Re: McPhillamys Gold Project (SSD 9505) – Questions on notice

This letter provides responses to the questions posed by the Independent Planning Commission (the Commission) in relation to the McPhillamys Gold Project (the project), during its meeting with Regis Resources Ltd (Regis) on 6 December 2022 and confirmed in writing on 15 December 2022.

Figure 1: Effect of salinity on evaporation rate (Bonython, 1966)

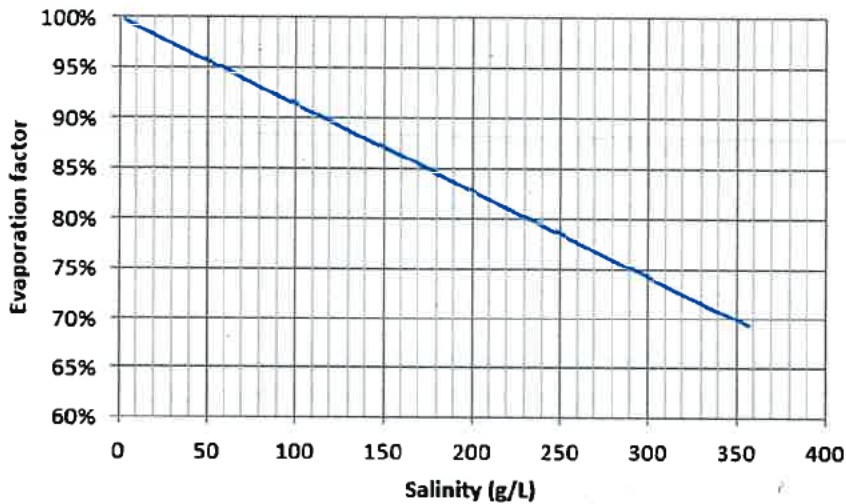
b) The decant water or water on top of the Tailing Storage Facility will become highly saline and – for example, at year 8 of operations – there would likely be some flow on impacts, such as limits to the rate of evaporation and operational impacts. Have these implications been taken into account?

In relation to the effect of salinity on evaporation, research in the Dead Sea has shown that at daily evaporation rates of around 10 mm/day (typical in Australia) water saturated with salt (357 g/L) will evaporate at around 65% of the rate of fresh water (Mor et al, 2018, <https://doi.org/10.1002/2017WR021995>). This recent finding aligns with the empirical curve published by Bonython, C. W. (1966) (see Figure 1). At moderate salinity (less than seawater salinity), evaporation may be reduced by between 1-3%.

As described in more detail in the answer to question 2(b) below, water quality in the TSF is predicted to remain brackish at < 4,500 mg/L TDS which, as shown by the factors in Table 1, would not materially affect the evaporation rate.
